反對錦上路丈量 DD112 Lot 246 862 和毗連政府土地
(申請編號：Y/YL- SK/1)

Y/YL-SK/1

Lots 246, 247 (Part), 251 (Part), 253 (Part), 254, 255 (Part), 256, 257, 258 (Part), 260, 263, 273 RP, 274, 275, 277, 278 S.B, 279, 280, 284, 294 RP, 295, 849, 850, 851 (Part), 853, 856 (Part), 859 (Part), 861 (Part) and 862 in D.D. 112 and Adjoining Government Land, Kam Sheung Road, Shek Kong

Re: Comments to the Town Planning Board in respect of Application Y/YL-SK/1

Fig.1 Wah Yuen, as shaded in yellow (Source: Gist Pg 9: Indicative Master Layout Plan)

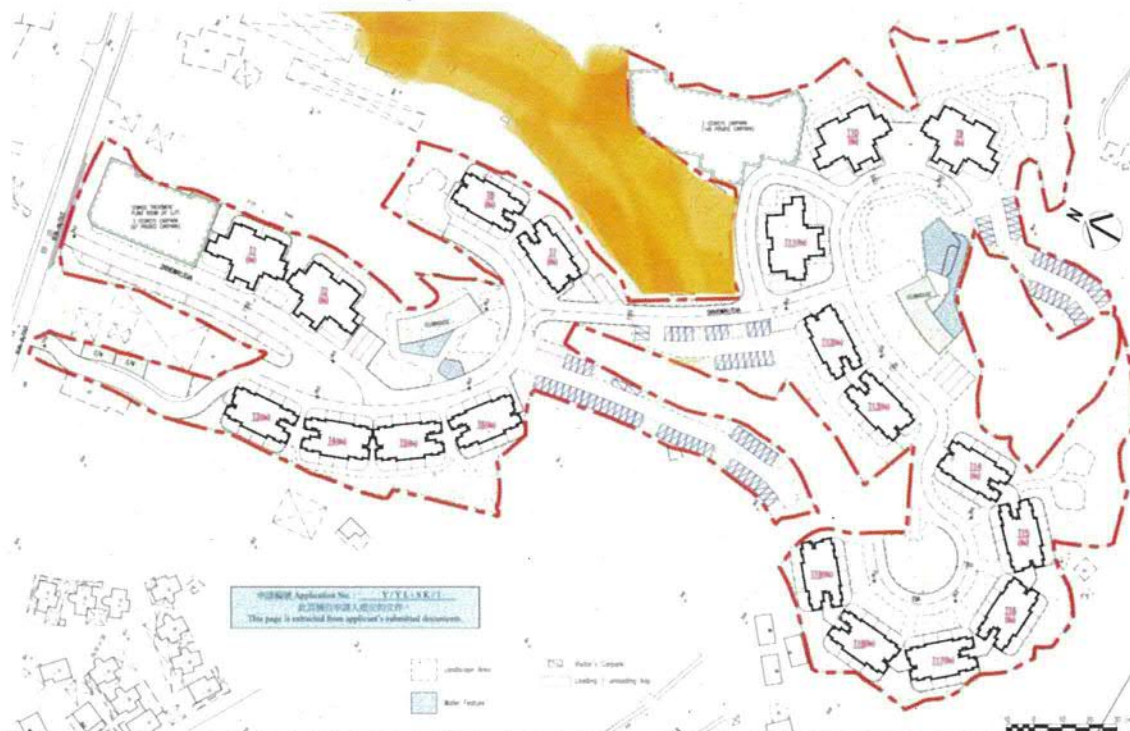
Wah Yuen is a private compound comprising 9 detached houses each with spacious garden, founded by eminent members of the society back in the late 1970s, including Dr Chiu Hin Kwong OBE, JP [招顯洸醫生 OBE 太平紳士], whose name is widely recognised by the Chiu Hin Kwong Heart Centre of the Hong Kong Baptist Hospital, Professor Philip Shen, formerly College Head of Chung Chi College, CUHK (沈宣仁教授, 曾任崇基學院院長等職), and local successful business families. The choice of land was abundant at the time and the location of Wah Yuen was picked with optimal fung shui benefits, with view of the Tai Mo Shan mountain from all our windows. The location was chosen to ensure privacy, hence setback away from the main road by around 90m.

There is no part in the Application where Wah Yuen is mentioned. And from the plan of the PD, it seems that the Applicant has not taken the welfare of Wah Yuen into consideration at all. Our environment in Wah Yuen is detrimentally affected by the PD, yet there is total absence of mentioning of Wah Yuen in ALL of the consultants' reports (Traffic / Landscape / Visual / Noise / Drainage / Sewerage / Water Supply).

Fig. 2 Aerial Photo of the Site (Source Fig 4.2 of Executive Summary)

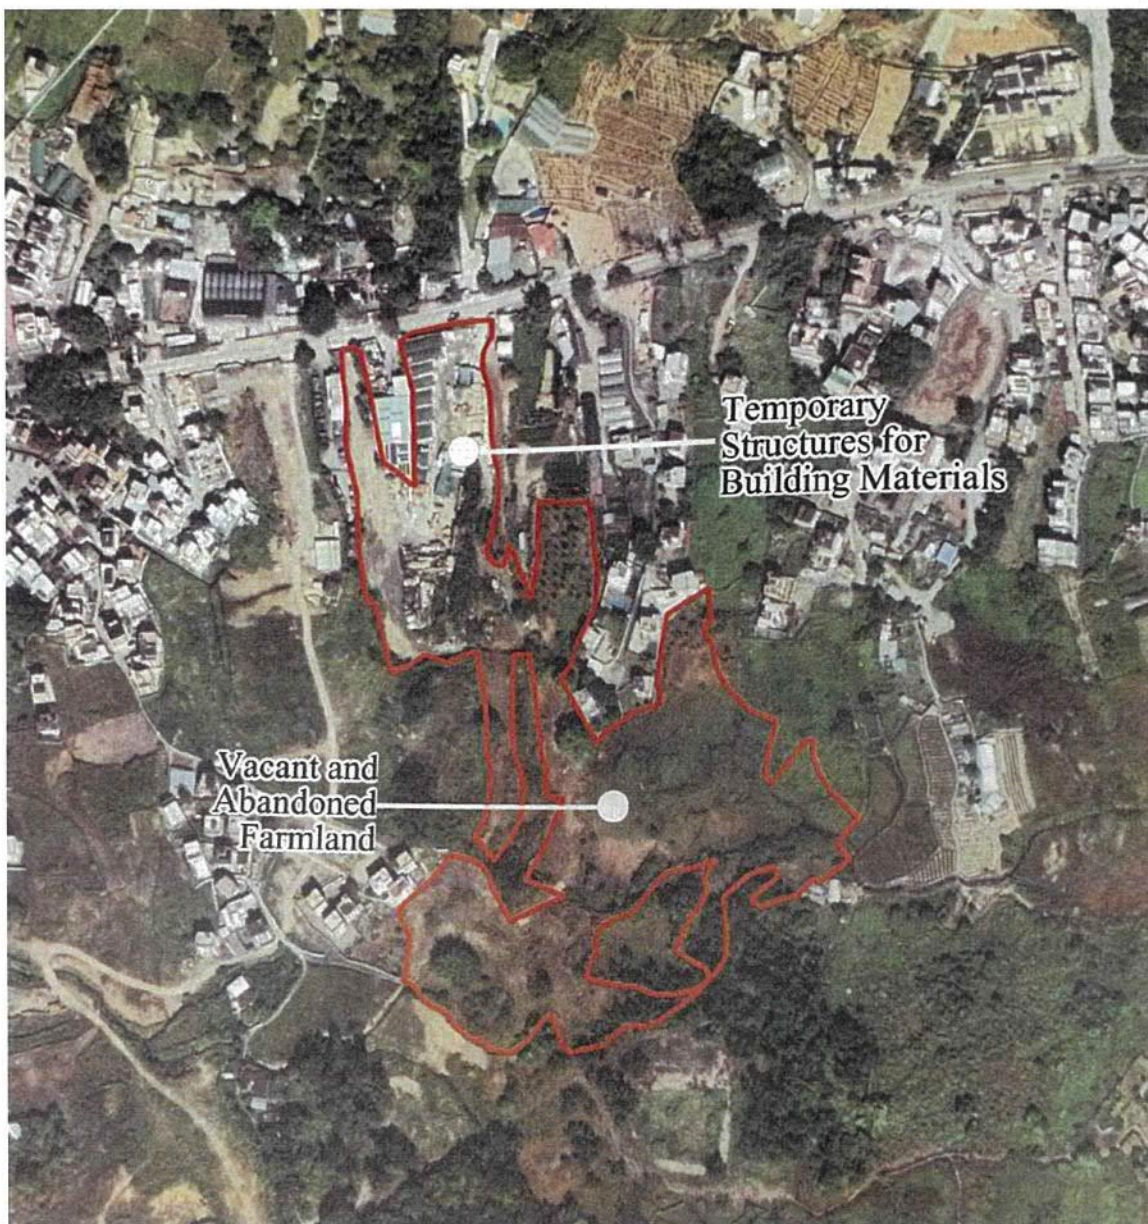
Due to limited budget, we can only show the visual above using one angle. However, guess it needs no imagination to visualise that our houses will be totally walled in. This has a devastating impact on our lives, as well as the monetary values of our properties.

Has there been consideration of the complete visual blockage of all our views in Wah Yuen when the plan is 'kissing' our houses ?

The question of why, of all the planning of the buildings the Applicant can have, why the current plan has to have 6-storey buildings and 3-storey carpark RIGHT ADJACENT to our houses ?

Fig.1 Wah Yuen, as shaded in yellow (Source: Gist Pg 9: Indicative Master Layout Plan)

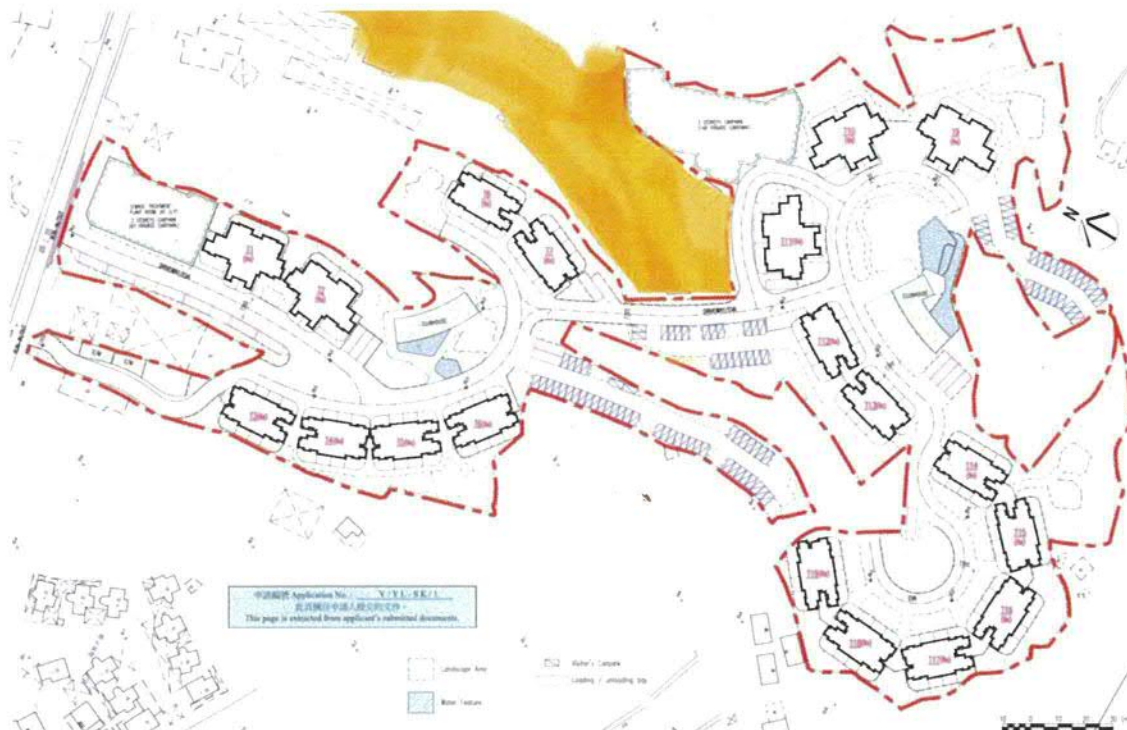
There is no part in the Application where Wah Yuen is mentioned. And from the plan of the PD, it seems that the Applicant has not taken the welfare of Wah Yuen into consideration at all. Our environment in Wah Yuen is detrimentally affected by the PD, yet there is total absence of mentioning of Wah Yuen in ALL of the consultants' reports (Traffic / Landscape / Visual / Noise / Drainage / Sewerage / Water Supply).

Fig. 2 Aerial Photo of the Site (Source Fig 4.2 of Executive Summary)

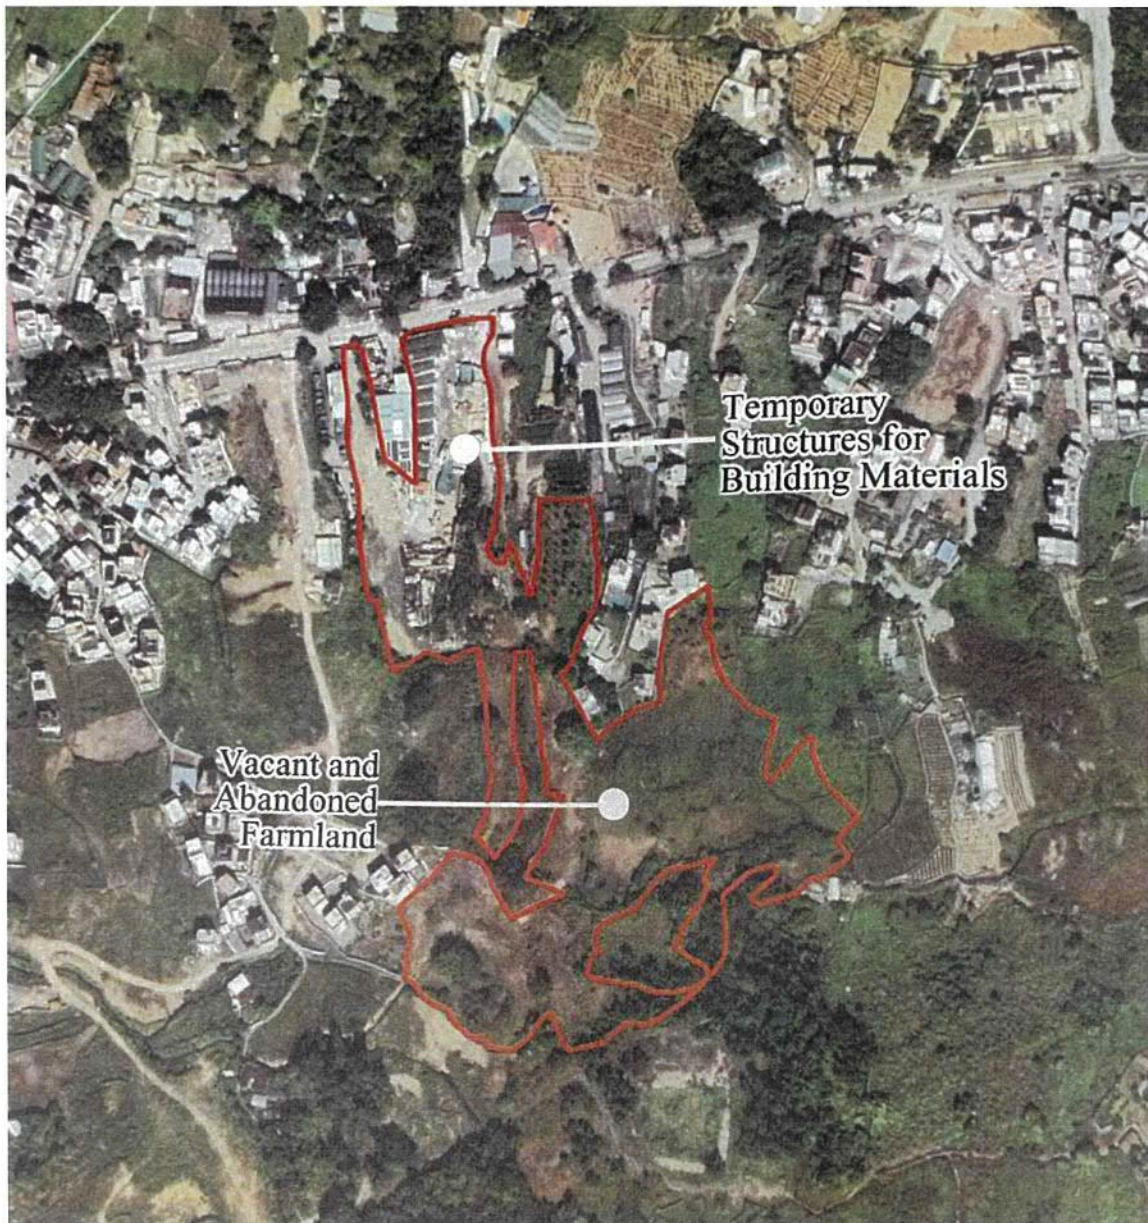
Due to limited budget, we can only show the visual above using one angle. However, guess it needs no imagination to visualise that our houses will be totally walled in. This has a devastating impact on our lives, as well as the monetary values of our properties.

Per the proposed plan, on the west side of our house it is proposed that there will be 2 6-storey buildings T7 and T8, closest being at around 4 metres away from us. All the green views that we have will be gone, instead it will be 2 x 6 storeys worth of someone's living rooms / bedrooms and domestic noise, at stone's throw distance. Privacy and our peaceful life will be totally gone. This has a devastating impact on our lives, as well as the monetary values of our properties.

Looking at the plan of the PD, the Applicant 'cleverly' planned their 3-storey car park in this protruding part of their plot, away from their 'neatly ordered' residential buildings. This is truly an negative illustration of "Do unto others as you would have them do unto you". This is totally totally unfair and unethical. Besides, we will be suffering from the fumes of the 24/7 operation carpark right in front of our house, how is it possible that such planning can be allowed ?

Photos (per fig 3.3) and revised maps are included to show the existing watercourse near to Wah Yuen (Appendix B1, B3).

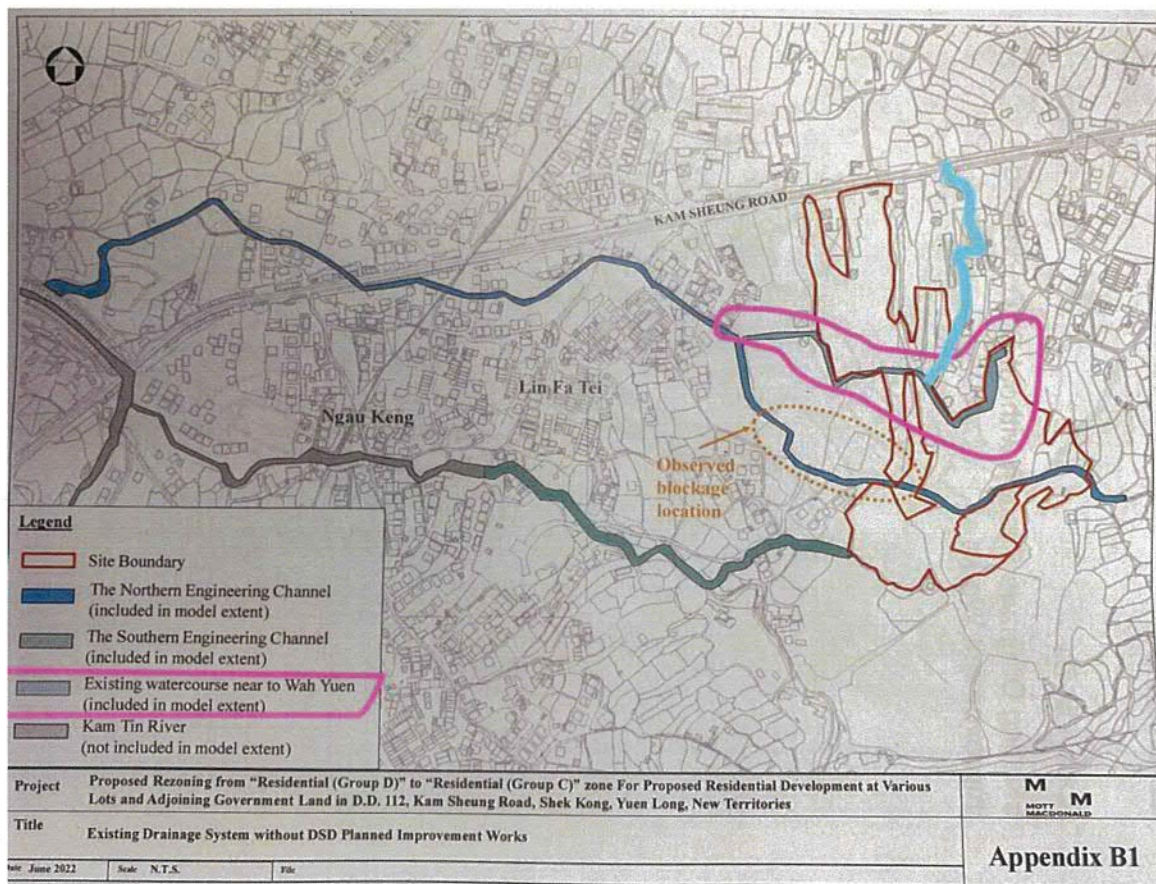
We are not expert in drainage issues, but at least for now, this part of the watercourse near Wah Yuen has been taken into consideration. Whether the findings and conclusions will hold against rainstorms is a question we trust we shall leave in the good hands of the various governmental departments.

- Another Wah Yuen watercourse along its western wall – no mentioning of

3. Annex 4 - Revised page of Drainage Impact Assessment

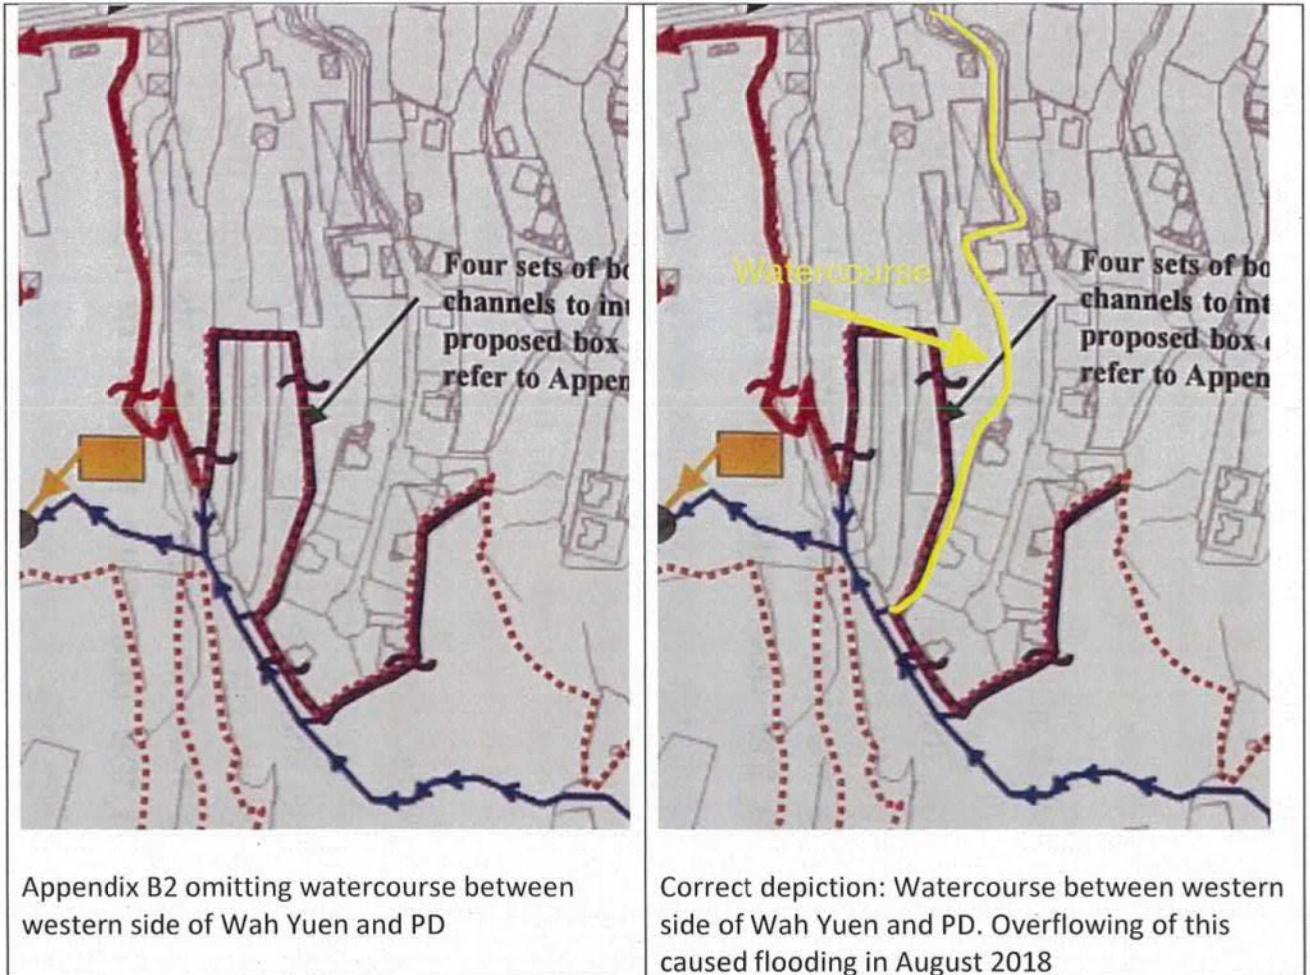
Appendix B2 – Again watercourse between western wall of Wah Yuen and that of the PD not shown.

Given that the watercourse (depicted in yellow above) has been omitted all along, we are very concerned as to whether all has been considered in ensuring that the PD will not cause extra risk of flooding to us.

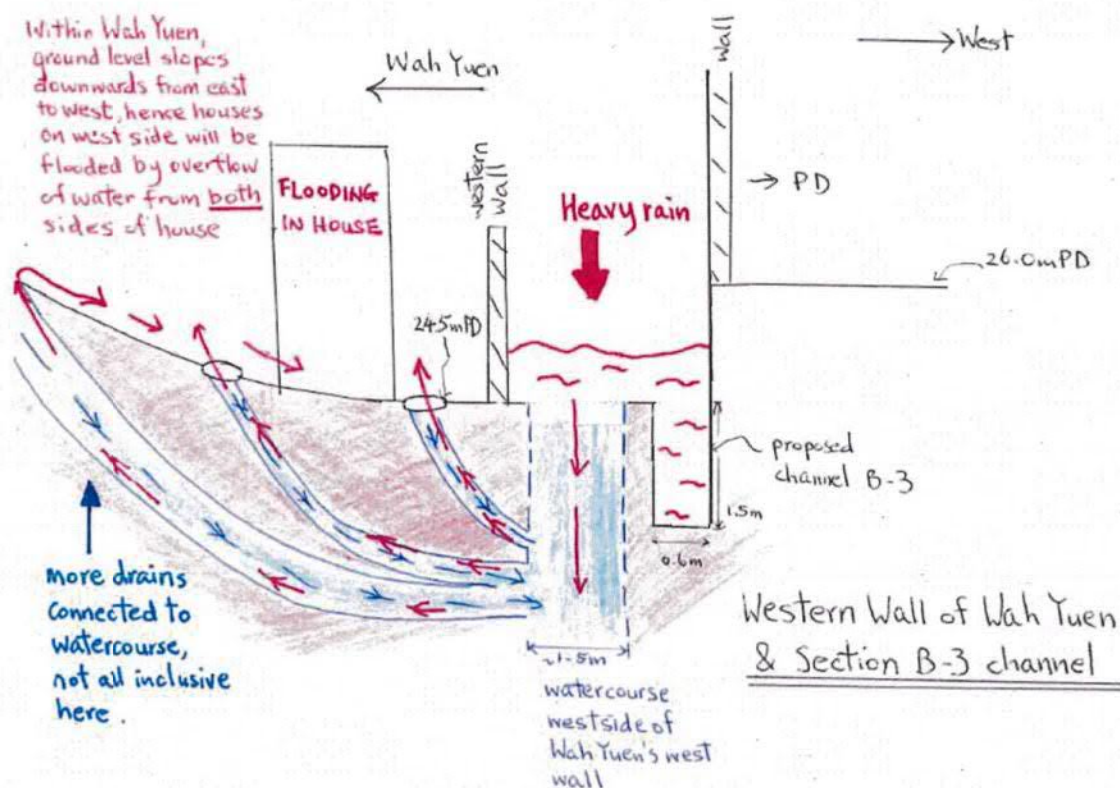
Why are the channels not built deeper and wider ? Annex A shows cross-sections of the Proposed Boundary Channels, in all the 200A cases for each of the proposed channels, water level is only 0.1 to 0.2 mPD below that of Wah Yuen or adjacent private lots, this margin is just too narrow. If water level exceeds that of the hypothetical case 200 A, the mere 0.1-0.2m cushion is totally insufficient. Afterall, given the raised level of the PD to 26.0mPD, and with their solid Proposed Boundary wall, if water level increases above the projections, they will only flow towards Wah Yuen and the adjacent private lots as the PD will be totally walled off from any waterflow. This is a much worse situation than if the PD had not been built. Without the PD, overflowing water would be able to be absorbed by agricultural land and soil and gets runoff in all directions. However with the PD, any waterflow will be trapped between the PD Proposed Boundary Wall and the wall of Wah Yuen. Given that units in Wah Yuen drains out to the waterways outside the wall, overflowing water between the 2 walls will flow into our houses in Wah Yuen and our risk of flooding will be CATASTROPHICALLY increased. This is not a matter of negotiation, but should just not be allowed to take place.

Showing the comparison between Existing Conditions vs Proposed Condition for Section B-1, B-2 for Wah Yuen is totally misleading. As soon as the water level rises above that of the ground level of Wah Yuen or Adjacent Private Lots, water will have nowhere to go except for overflowing into Wah Yuen/ Adjacent Private Lots at much higher speed and capacity as it has nowhere else to be channelled off as PD's wall stops all water from going their way.

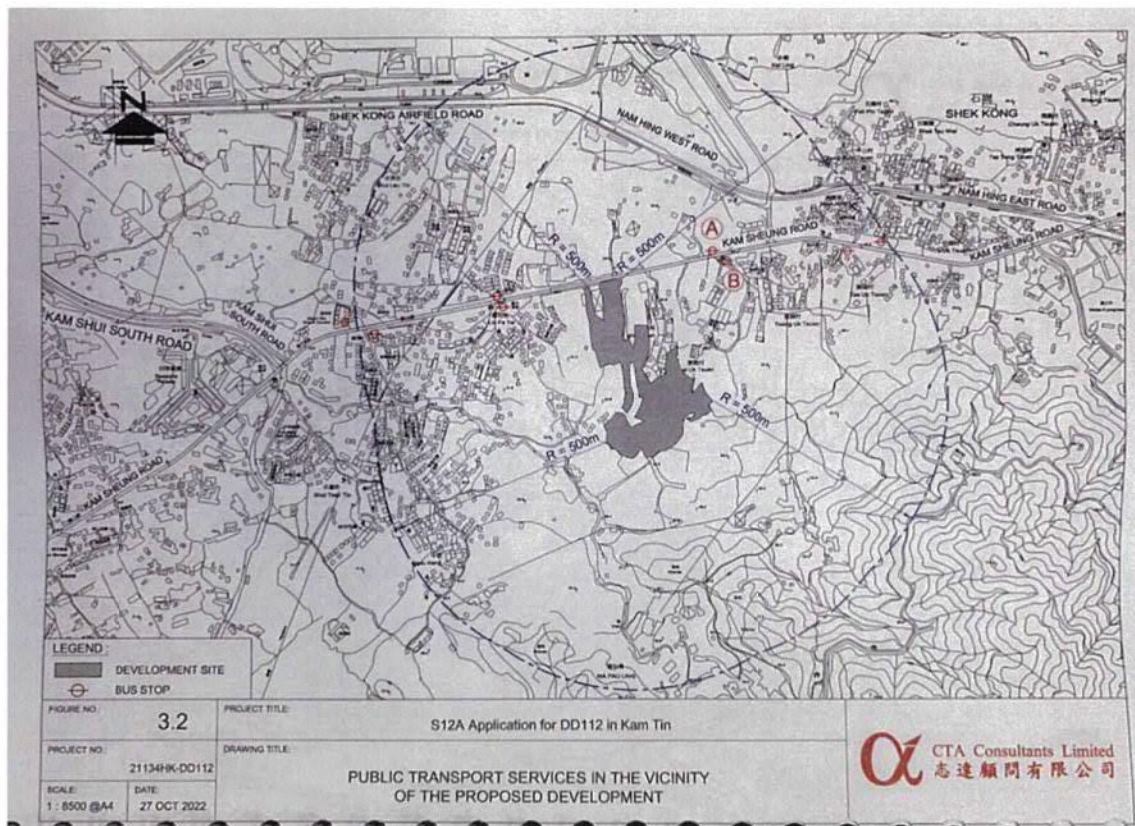
The location where the surveys were conducted i.e. during AM Peak (7:30 – 8:30) at Stop B westwards and PM Peak (18:00 – 19:00) at Stop A eastwards totally misses the issue.

Take for example bus 64K, during peak hours, say AM, with most public transportation demand being westwards towards Kam Sheung Road MTR. Once the bus reaches Kam Sheung Road (from Tai Po), there are a total of 18 bus stops from Kam Sheung Road (Sheung Tsuen Playground) westwards to Kam Sheung Road MTR. Bus Stop Lai Uk Tsuen (named Bus stop B in the Traffic Impact Assessment Report) is only the 4th bus stop along Kam Sheung Road from the Sheung Tsuen Playground bus stop. The bus still has capacity, hence 'meeting the demand of the residents of the PD', satisfying the Applicant's needs. Yet, very soon, as the bus passes Lin Fa Tei and westwards beyond, number of passengers boarding drastically increases as these are the more densely populated villages. It is not unusual that the bus reaches full capacity, with all passengers standing up to the driver's seat in the later bus stops along Kam Sheung Road.
